Re: Appeal of FEMA's Preliminary Flood Insurance Rate Maps for New York City

# APPEAL OF FEMA'S PRELIMINARY FLOOD INSURANCE RATE MAPS FOR NEW YORK CITY

**By the City of New York**

**Mayor's Office of Recovery and Resiliency**

**Figure 1-2. Citywide comparison of the 2007 FIRM and 2015 PFIRM 1-percent-annual-chance floodplains.**

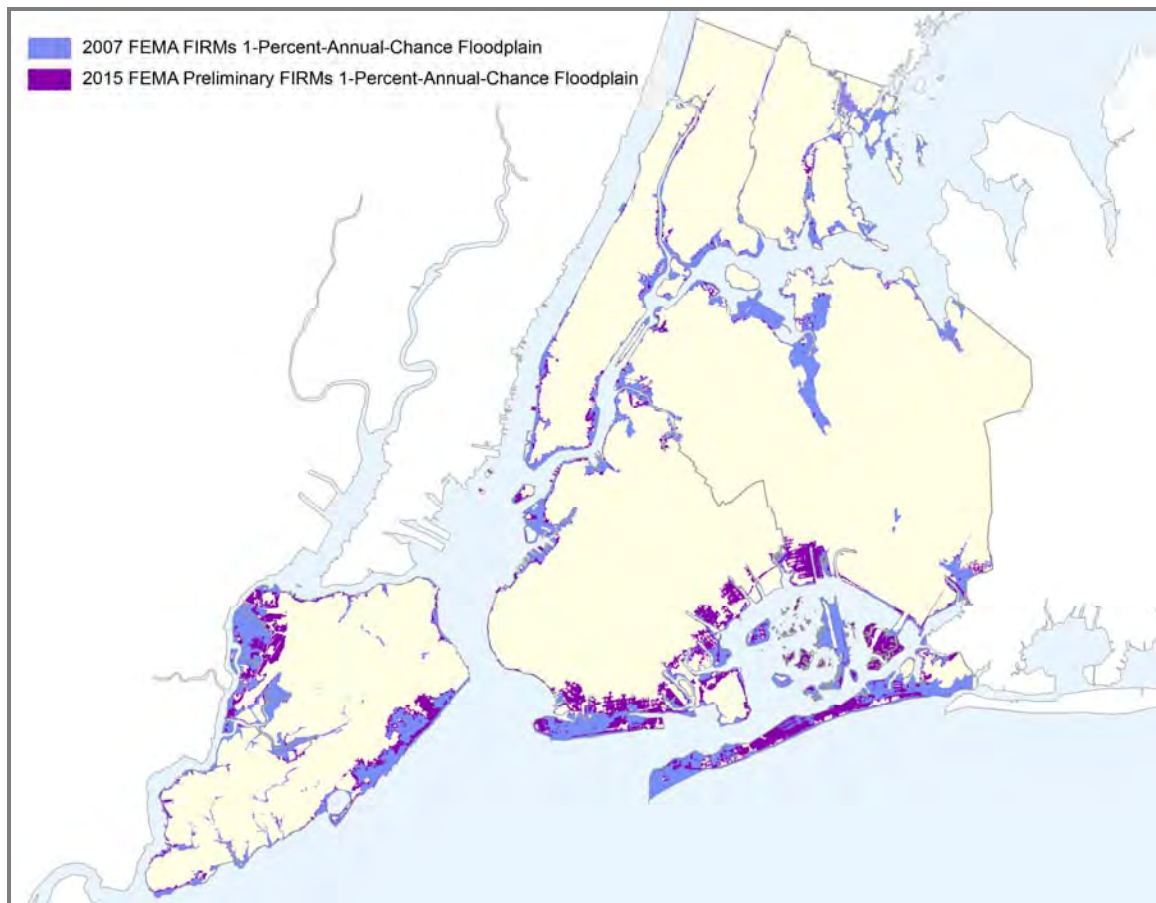
Table 1-1 demonstrates that percent-annual-chance stillwater elevations from the 2015 PFIRMs significantly changed relative to the 2007 FIRMs. Specifically, the 1-percent-annual-chance stillwater elevation increased by 2.7 feet at The Battery. Changes in stillwater elevations resulted in changes to the SFHA boundaries between the 2007 FIRMs and 2015 PFIRMs throughout New York City, as shown on Figure 1-2. Variations in the SFHA boundaries are most substantial near Rockaway Peninsula, Jamaica Bay, Lower Manhattan, Newtown Creek, and Staten Island.

**Figure 1-6. Difference (feet) in 1-percent-annual-chance stillwater elevations between the 2015 PFIRMs coastal analysis and the City's analysis in the study area.**

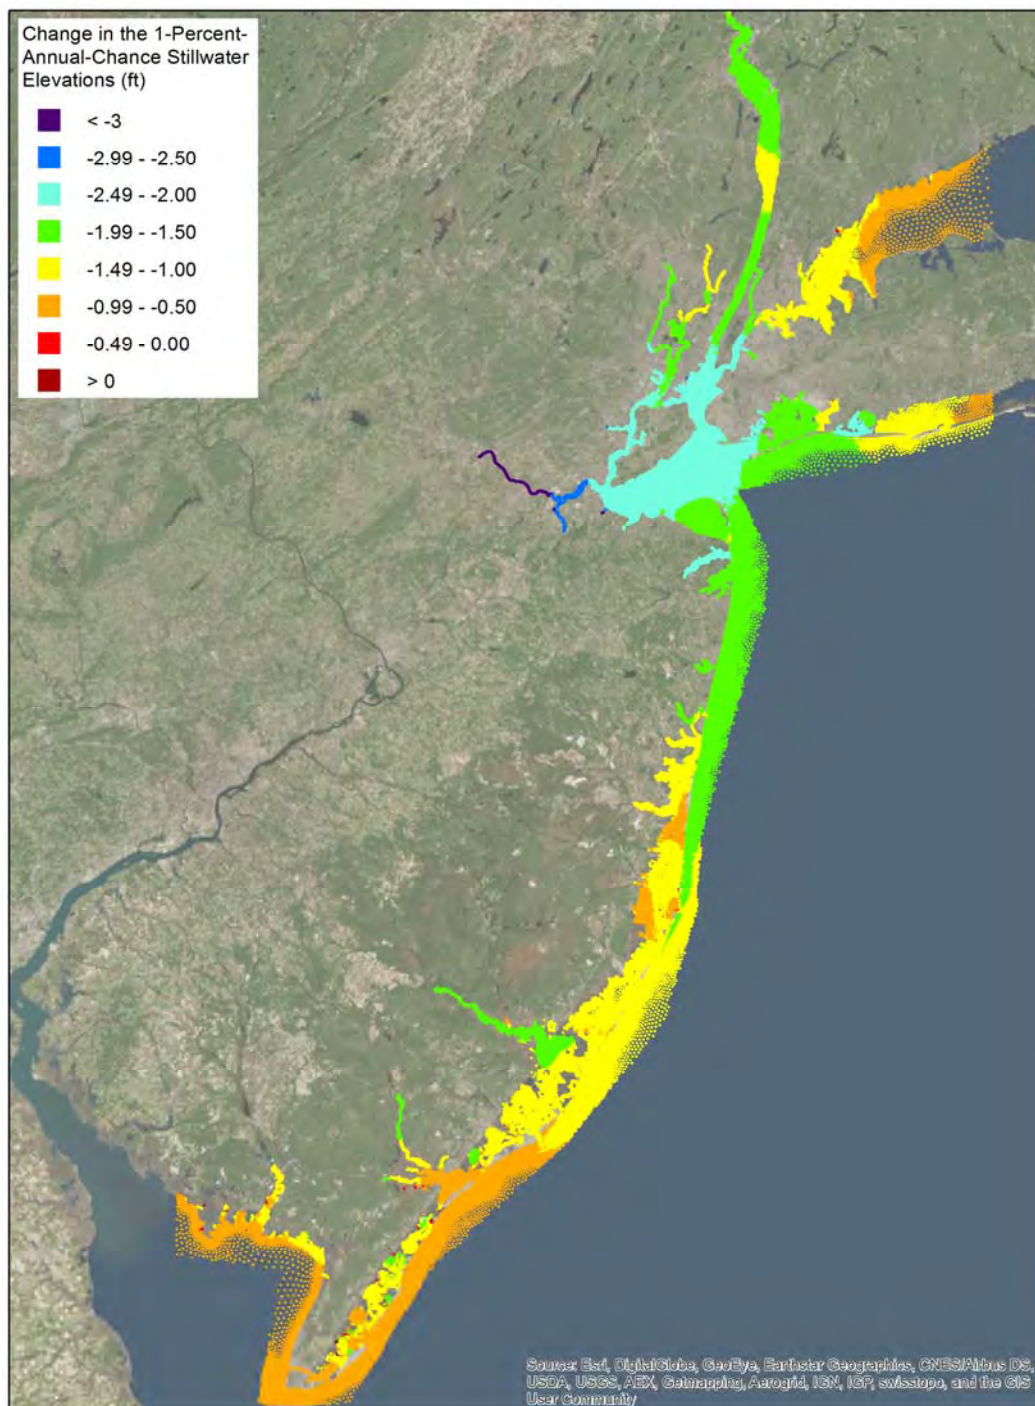
shown on Figure 1-6. Table 1-3 shows the changes to the 10-, 2-, 1-, and 0.2-percent-annual-chance stillwater elevations at six NOAA gage stations within the study area. Changes to the 1-percent-annual-chance floodplain extents (SFHA boundaries) between the 2015 PFIRMs and the City's analysis are shown on Figure 1-7. Table 1-4 shows revised estimates of buildings, residents, one- to four-family homes, and constructed floor area in the 1-percent-annual-chance floodplain based on the City's new coastal analysis described within and a comparison of these estimates to those created based on the 2007 FIRMs and 2015 PFIRMs.

Figure 2-1. FEMA's peak storm tide elevation (feet) comparisons for the 1984 ET storm (FEMA 2014c) for high water marks and gages.

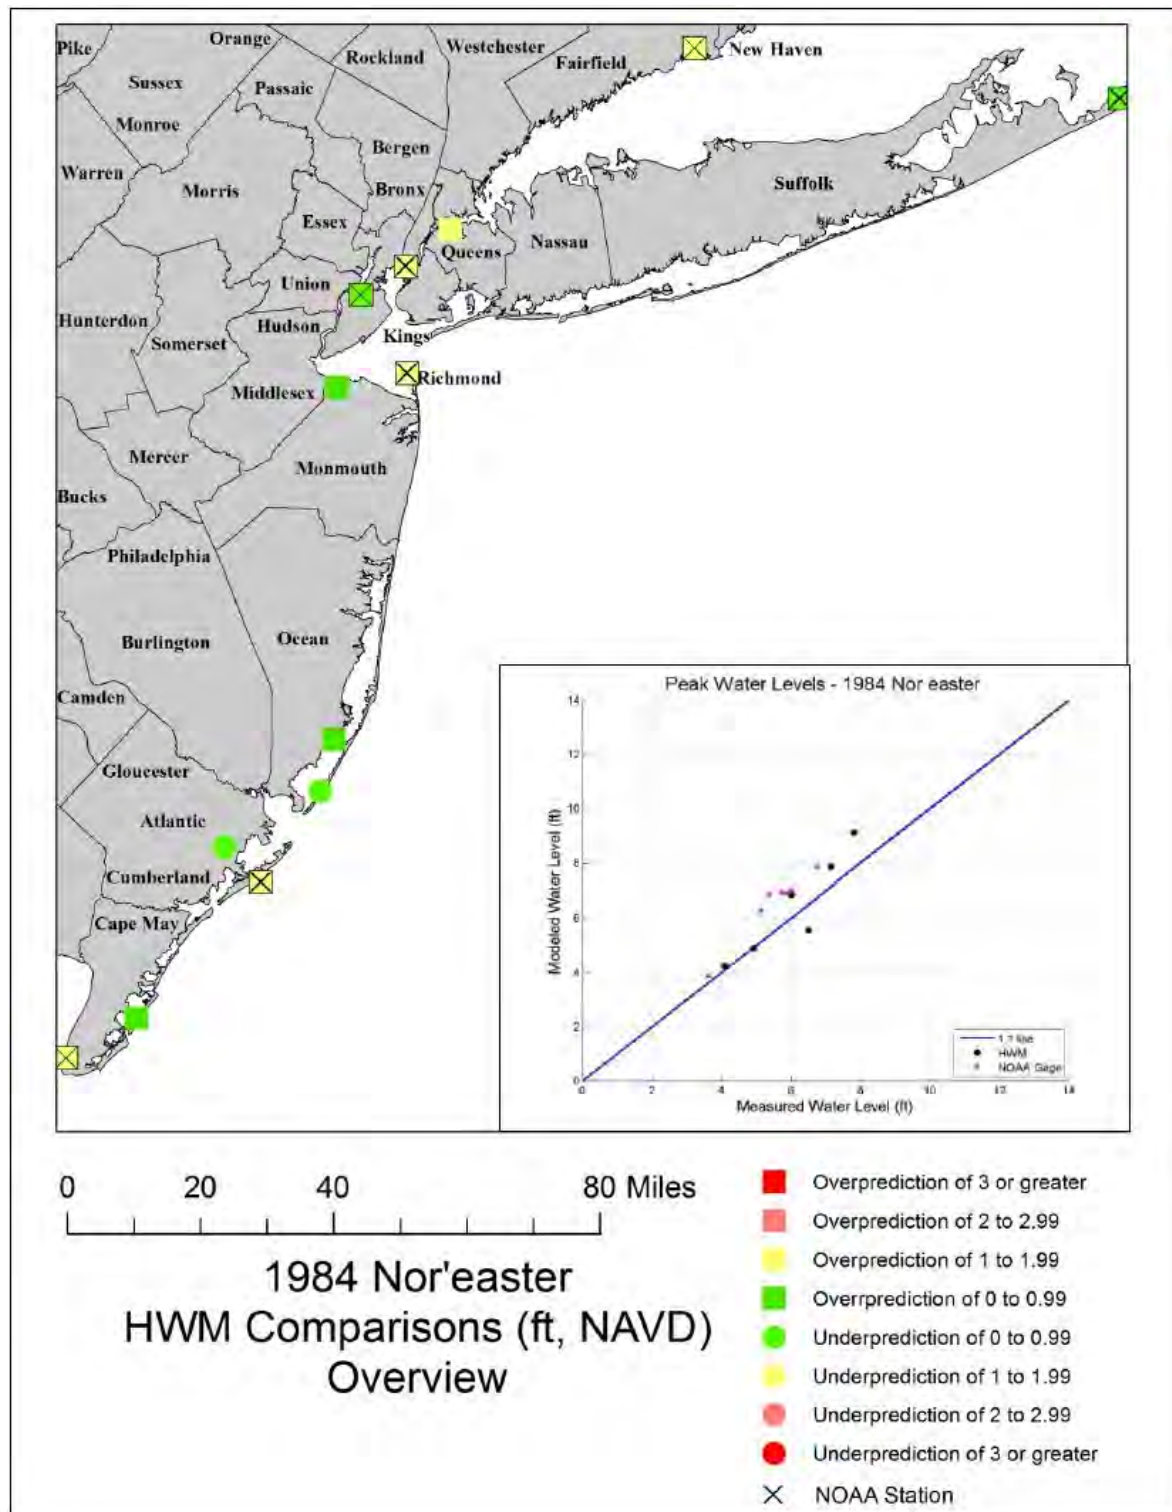
To quantify the model skill at simulating storm tide peak elevations, the quantiles of the 215 simulated storm tide peaks were calculated and compared to the quantiles of observed storm tide peaks using a GEV distribution function. Figure 2-4 is a quantile-quantile (Q-Q) plot showing the quantiles of simulated results (vertical axis) using FEMA's PFIRM coastal analysis model setup (including the original 1950 ET storm meteorological conditions) versus the quantiles of NOAA observations adjusted to the mid-point of the 1983-2001 NTDE (horizontal axis). The blue crosses are the 215 data points, the black line is the 1:1 line, and the red line illustrates the slope and intercept to fit the 215 data points. The Q-Q comparison results in a root-mean-square error (RMSE) of 0.49 foot and a slope of 1.239. The notable deviation of the data points from the 1:1 line (or best-fit line) clearly demonstrates that the model results using FEMA's PFIRM coastal analysis model setup overestimate storm tide elevations, especially those above approximately 6 feet MSL. The model bias demonstrates that FEMA made a technical and scientific error by not validating ADCIRC+SWAN to an acceptable degree.

**Figure 2-5. FEMA scatter diagram showing relative residuals.**

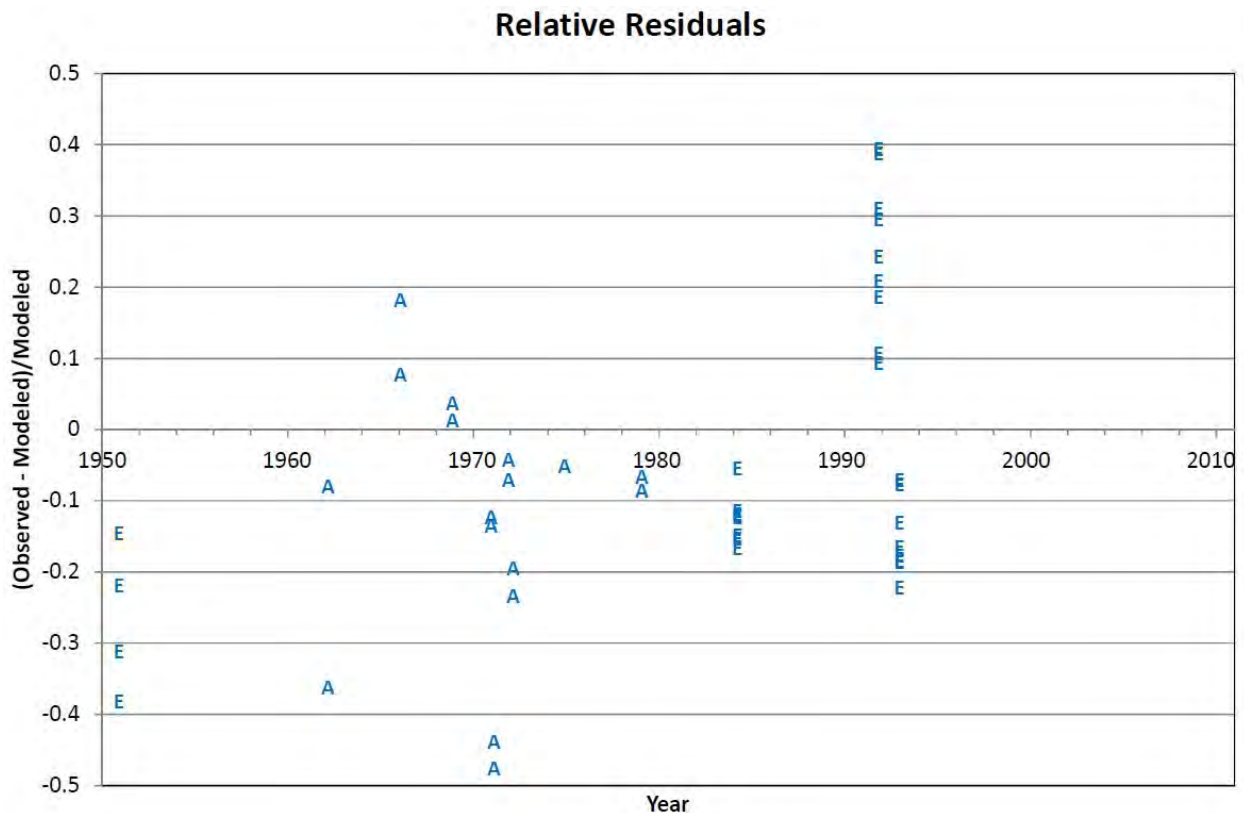
It should be noted that, following FEMA's PFIRM coastal analysis, FEMA's March 2015 memorandum (RAMPP 2015) documented an additional analysis of potential errors and biases in ADCIRC+SWAN simulations beyond the initial model validation efforts documented by FEMA (FEMA 2014c). As described in the March 2015 memorandum, normalized residuals were computed by subtracting tides from the total water levels for selected ET storms at selected model output locations and compared with the residuals computed from NOAA observations (Figure 2-5). The conclusion of the analysis was that no model bias existed. Specifically, the March 2015 memorandum concluded that "these sensitivity analyses reinforce the conclusion that the normalized residuals for the ETs have no bias and a standard deviation of 21 percent. When taken in the context of all the data shown...the residual for the November 1950 ETs at the Battery gauge is relatively unremarkable."

Lastly, as noted previously, the only ET storm with significant model underestimation in FEMA's PFIRM coastal analysis is the 1991 storm, as shown on Figure 2-5. Unlike the surge responses in the other 29 ET storms that were driven by direct wind forcing, the ADCIRC+SWAN model results indicate that storm tide elevations in the 1991 storm were driven by wave radiation stresses from the large offshore waves propagating toward the coast. The underestimation of the 1991 ET storm additionally indicates that the wave radiation stresses were not fully captured in FEMA's PFIRM coastal analysis ADCIRC+SWAN model. As shown on Figure 2-6 and in Appendix A, the winds were blowing offshore during the time of major surge generation, meaning that winds did not drive surge into the harbor for the days leading up to the peak storm tide and that FEMA's assumption that the cause of the underestimation was the meteorological forcing is likely incorrect. Ultimately, this is a relatively minor issue but worth noting due to the unique nature of the 1991 storm simulation and the fact that FEMA did not invest adequate time and effort to understand the biases in the simulation of the 1991 ET storm and improve upon the individual simulation and treatment of the ET storm suite as a whole. Hence, beyond the fact that normalized residuals should not be used to assess model performance in general, the 1991 ET storm model underestimation should not be considered an offset to the model overestimation of the majority of wind-driven surges (i.e., different physical processes are the causes of under- and overestimation). Regardless, even with the incorporation of all 30 ET storms including the 1991 ET storm, FEMA's PFIRM coastal analysis model shows a clear bias high (Figure 2-4).

**Figure 3-6. Maximum storm tide elevation differences (feet) for the 1950 ET reanalysis due to changes in the SWAN model setup for courant parameters and convergence criteria.**

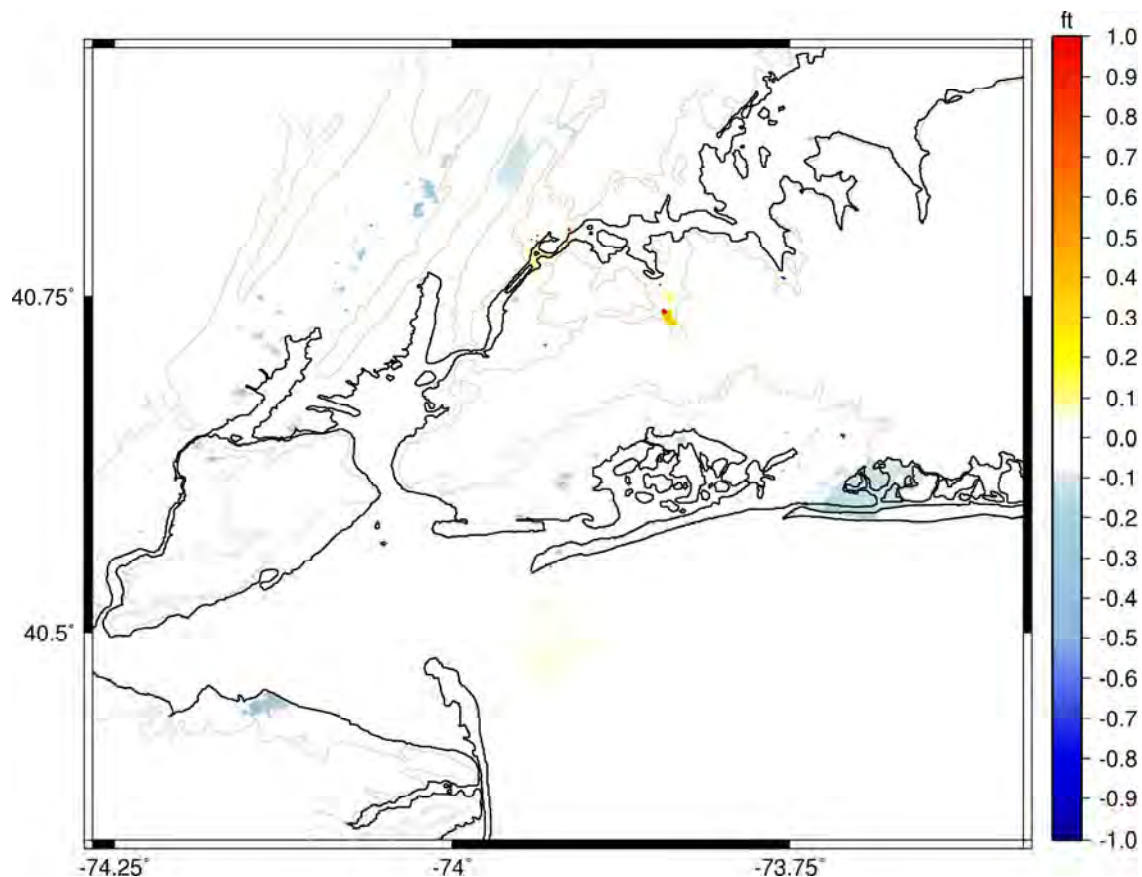
5. The SWAN model wet node convergence criteria were adjusted from 99 percent to 95 percent, significantly reducing model runtime. As shown on Figure 3-5, for the 1950 ET storm reanalysis, which is representative of all ET storms in this instance, the FEMA PFIRM SWAN model convergence criteria were rarely, if ever, met by FEMA during the PFIRM coastal analysis. Instead, during FEMA's simulations, SWAN iterated 20 times (the maximum number of iterations as was set in the SWAN code), achieving the level of accuracy following the 20<sup>th</sup> iteration and not the accuracy set by the SWAN convergence criteria. Figure 3-5 shows that, by setting the convergence criteria to 95 percent, fewer model iterations (top plot) were necessary to provide nearly the same accuracy with each time step of the simulation (bottom plot). The change in SWAN convergence criteria decreased model runtimes by more than 30 percent. Figure 3-6 shows that the changes to the SWAN setup, both the courant parameters and the change in convergence criteria, resulted in minor changes in the simulated peak storm tide elevations.

**Figure 5-1. Areas excluded from the City's statistical analysis due to limited sample size.**

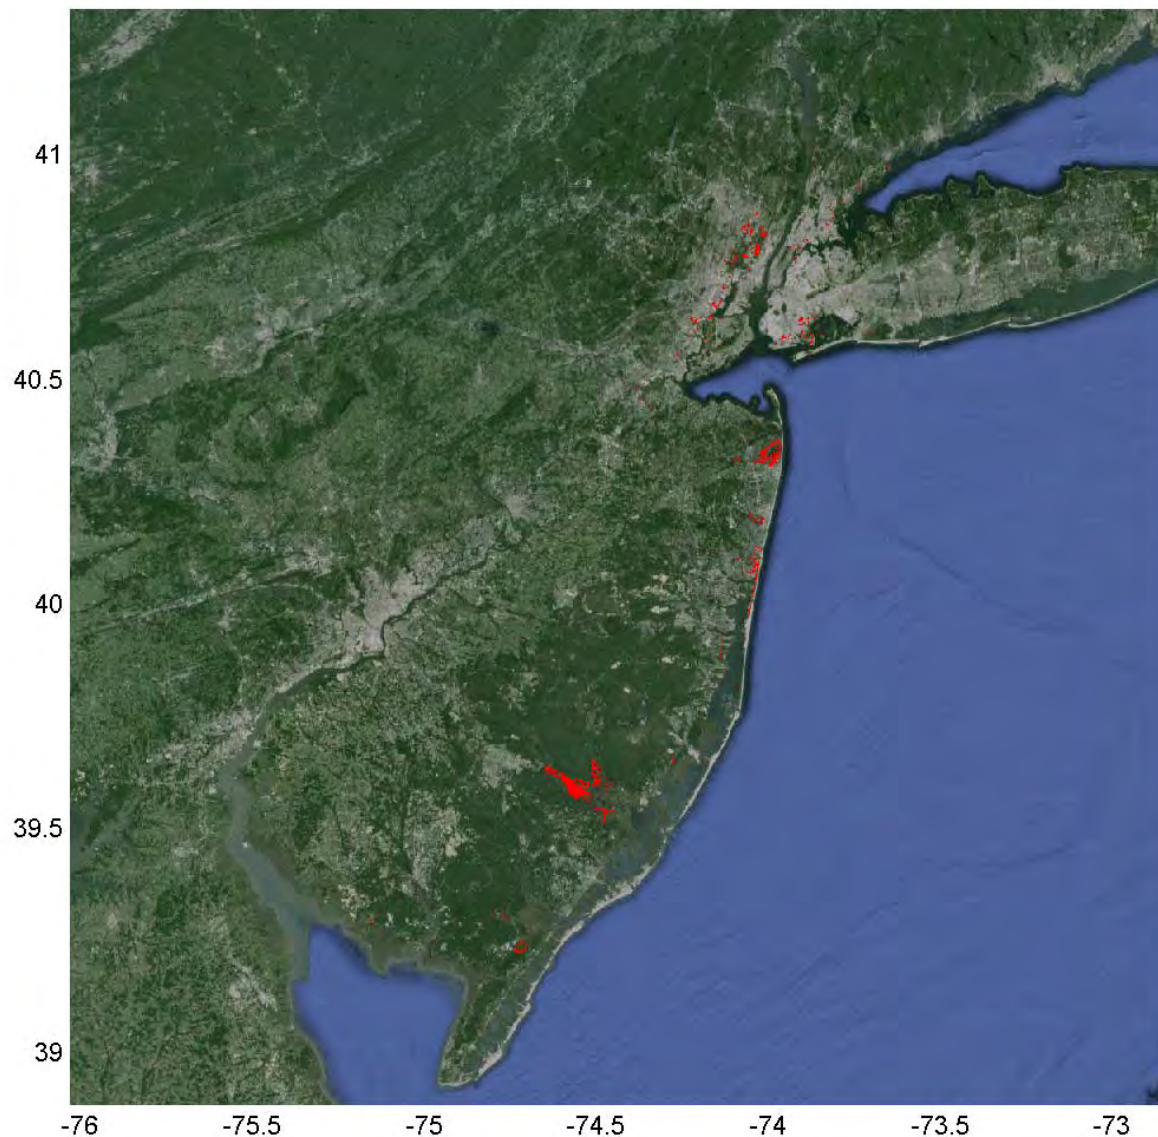
The second exception to FEMA procedures was that some ADCIRC+SWAN nodes that were included in FEMA's PFIRM statistical analysis were excluded from the City's analysis. Figure 5-1 shows the ADCIRC+SWAN nodes that were removed from the City's analysis because of fewer flood responses and thus less reliable superposition (e.g., nonlinear effects) and exceedance probabilities. The City's new model setup produced overall smaller storm tide elevations; therefore, some areas where prevailing ground elevation is high and/or model resolution is low were flooded less frequently in the City's model setup than in FEMA's.

**Figure 5-3. Difference (feet) in 1-percent-annual-chance stillwater elevations between FEMA's PFIRM coastal analysis and the City's analysis in the New York City area.**

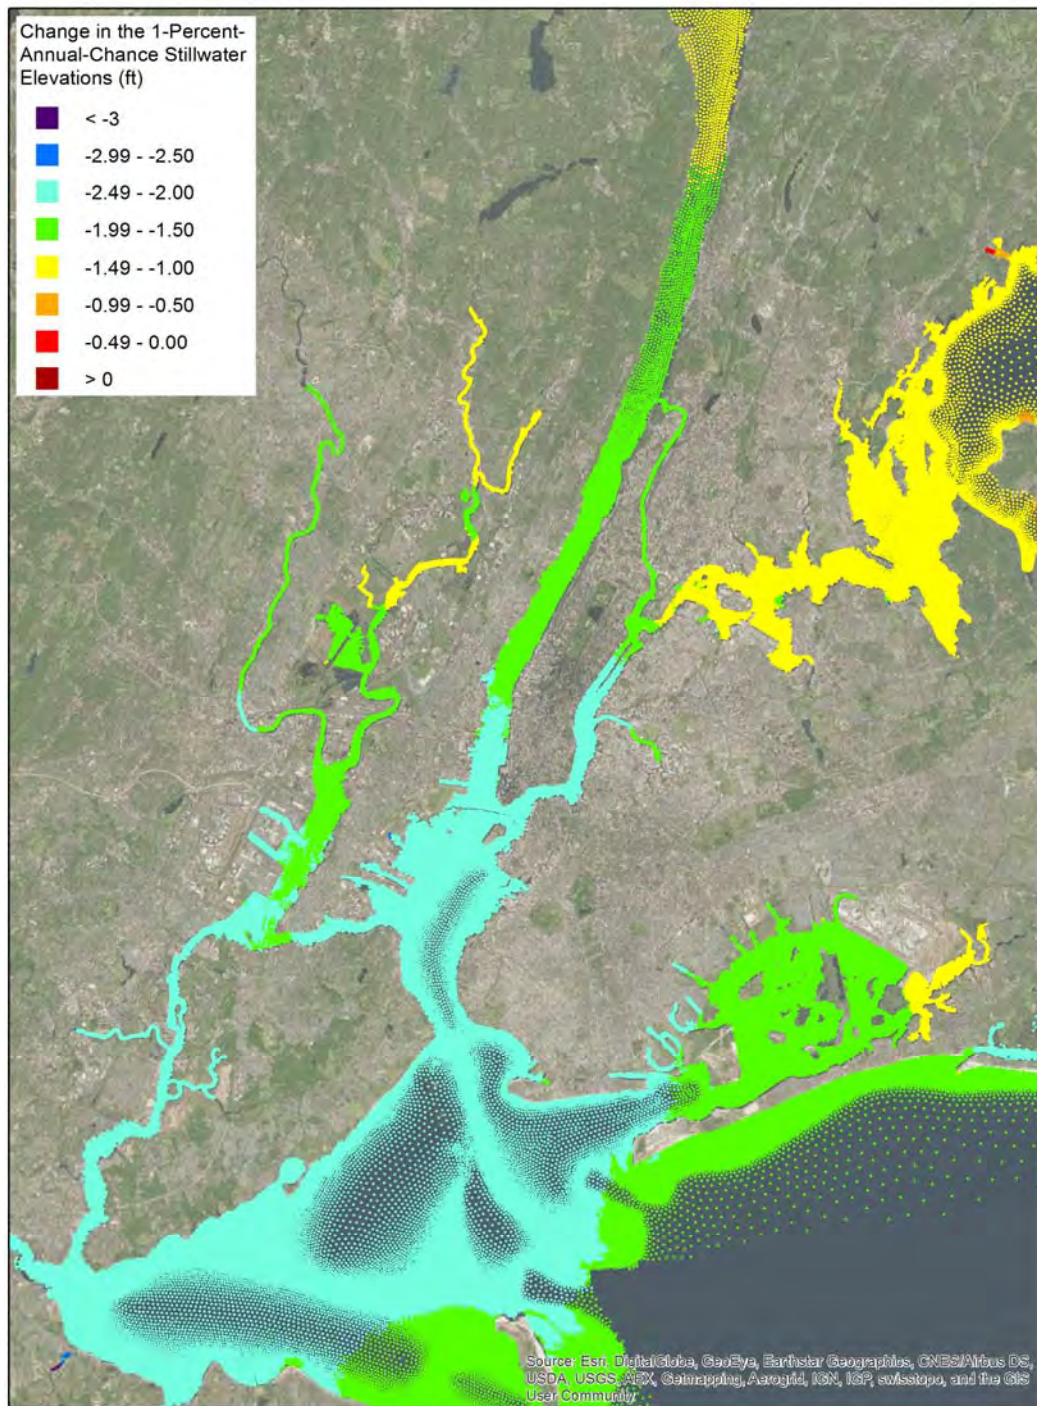
The City's revised ET storm statistical outputs combined with the tropical storm statistical outputs produced by FEMA resulted in revised total return stillwater elevations that correct FEMA's methodological and mathematical errors. Figure 5-2 shows the revised 1-percent-annual-chance stillwater elevations in the New York City area. Figure 5-3 shows reductions of over 2 feet in the 1-percent-annual-chance stillwater elevations between the City's analysis and FEMA's PFIRM coastal analysis. Similarly, 0.2-percent-annual-chance stillwater elevations and differences in stillwater elevations between the City's and FEMA's PFIRM coastal analyses are shown on Figures 5-4 and 5-5, respectively. Figures for the entire study area, including New Jersey, are provided in Appendix B. Stillwater elevations
